WCAP-17236-NP-A
Revision 0

Risk-Informed Extension of the Reactor Vessel Nozzle Inservice Inspection Interval

UNITED STATES
NUCLEAR REGULATORY COMMISSION
WASHINGTON, D.C. 20555-0001

SUBJECT: FINAL SAFETY EVALUATION FOR PRESSURIZED WATER REACTOR
OWNERS GROUP TOPICAL REPORT WCAP-17236-NP, REVISION 0, 'RISK-
INFORMED EXTENSION OF THE REACTOR VESSEL NOZZLE INSERVICE
INSPECTION INTERVAL' (TAC NO. ME4878)

Figure 3-3 Nozzle Weld Configuration Types

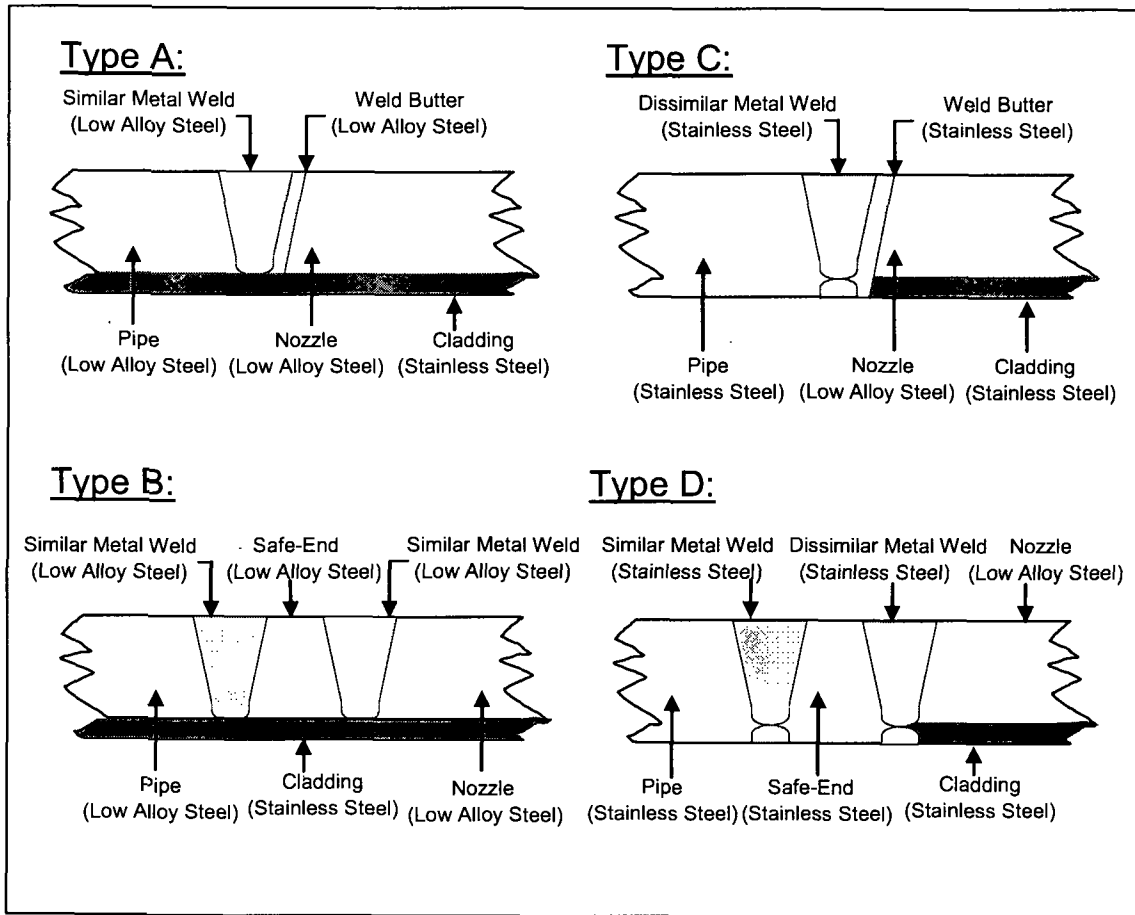
DCI-RAI-6 *Figure 3-3 of TR WCAP-17236 shows schematics of the four RV nozzle weld configurations. In reality, the diameter varies from the nozzle to the pipe. Identify the diameter that the PWROG used as input to the SRRA Code (nozzle diameter, pipe diameter, or something else) and justify the selection.*

DRA-RAI-2 *Tables 2-1 and 3-9 (and other tables) of TR WCAP-17236 direct that the change in risk includes a multiplier characterized as "(# of welds examined)." Figure 3-3 illustrates the different nozzle types where it appears that weld Types B and D have two welds per nozzle implying that the frequency results for these types of welds should be multiplied by 2. Other discussion and examples in TR WCAP-17236 imply that a frequency estimate is developed for each nozzle, not each weld in the nozzle. Is the "(# of welds examined)" more appropriately labeled "(# of nozzles examined)"? If not, please clarify what the relationship is between the (# of welds examined) and the number of welds in a nozzle.*

The response to DCI-RAI-6 clarified that the input of RV nozzle diameter may not reflect the real nozzle geometry. Instead, "all grouping of thickness and diameter inputs were evaluated...the grouping that provided the highest change in failure (MLOCA) frequency between 10-year and 20-year inspection intervals was selected as being limiting for that nozzle type." Therefore,

DCI-RAI-6 is resolved because the PWROG's approach of using the nozzle geometry that gave limiting results is conservative. Response to DCI-RAI-7 clarified that regardless what the SRRA input on flaw was called, "the SRRA Code simulate a maximum of one flaw at the worst stress location that could result in the first failure of the nozzle weld." Therefore, DCI-RAI-7 is resolved because the PWROG's approach of selecting the worst stress location for evaluation is conservative.

In order to calculate the change in risk for a specific plant, the number of welds examined must be multiplied by the summed changes in CDF and LERF results for all three failure modes (LOCA leak rates) as described in Section 3.2.4 of the TR. This change in risk is determined on a per weld examined basis and not a per nozzle examined basis. If there are two welds within a single nozzle and both of these welds are examined, then they must be included in the change-in-risk calculation. For example, if a 3-loop plant with Type D nozzles, as illustrated in Figure 3-3

"Therefore, for nozzle configurations (see Figure 3-3 in Section 3.2.3) where there are two welds per nozzle, the change in risk added to the change in risk from the RI-ISI element selection should be calculated based on one weld per nozzle."

Figure DCI-RAI-2-2 – Flow Chart for Piping Weld Failure Modes (from Reference 4)

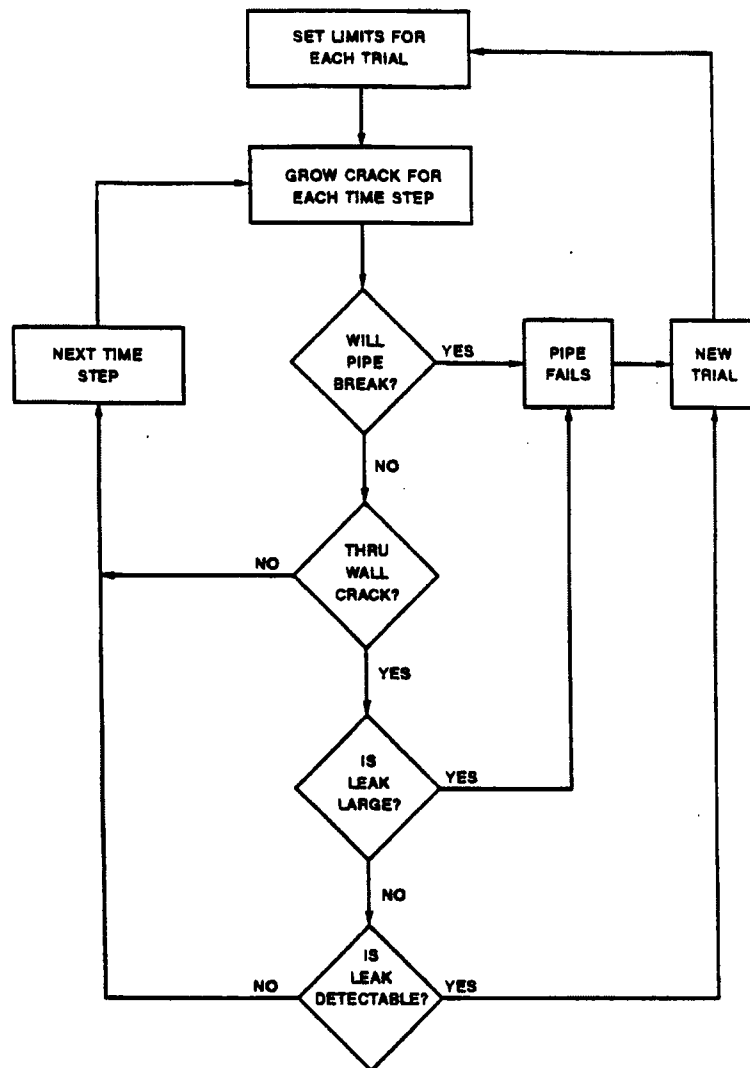
Since the TR contains no details of the PFM methodology used in the application, DCI-RAI-2 requested the PWROG provide a summary of the PFM analysis methodology used in the TR, including the analysis methodology type (elastic plastic fracture mechanics or linear elastic fracture mechanics), failure criteria, and the growth law for a flaw with an initial flaw depth to a critical size or through-wall flaw, and eventually to a long flaw corresponding to SLOCA, MLOCA, or LLOCA. DCI-RAI-2 also requested information regarding the establishment of fracture toughness and other material properties critical to failure resistance for each of the two failure periods for the RV nozzle welds and the key parameters which affect through-wall flow leakage, the leakage that is considered detectable, and how leak detection was credited.

How leak detection is credited is best shown in Figure DCI-RAI-2-2 (Figure 2-3 in the SRRA Supplement, Reference 4). For each random trial, the initial flaw size and crack size for a full break due to ductile rupture are set and the crack grows in depth and length due to the fatigue loading (stress range and number of cycles) for each time step, which is one year of operation. The growth in both directions to a through-wall flaw, and only in the length direction thereafter, was previously discussed in the Responses to Parts 1 and 2 of this RAI, respectively. Because a break due to ductile rupture from application of the design limiting stress could occur without a through-wall flaw, it is checked first to determine if failure occurs, and if so a new trial is initiated. If it does not fail, a check is made to determine if the flaw has grown through the wall. If not, the crack is grown for additional years of operation until 40 or 60 years is achieved and a new random trial is initiated. If it is through the wall, the length is checked to see if it will cause the specified large leak rate, such as that for a small, medium or large LOCA, and if so the pipe fails. If not, the crack length is checked to see if it exceeds that for a detectable leak of 1 GPM. If the leak is not detectable, the crack grows for another year due to fatigue loading and is then checked again for breaks and large leaks. If the leak is detectable, there is no failure and a new random trial is initiated.
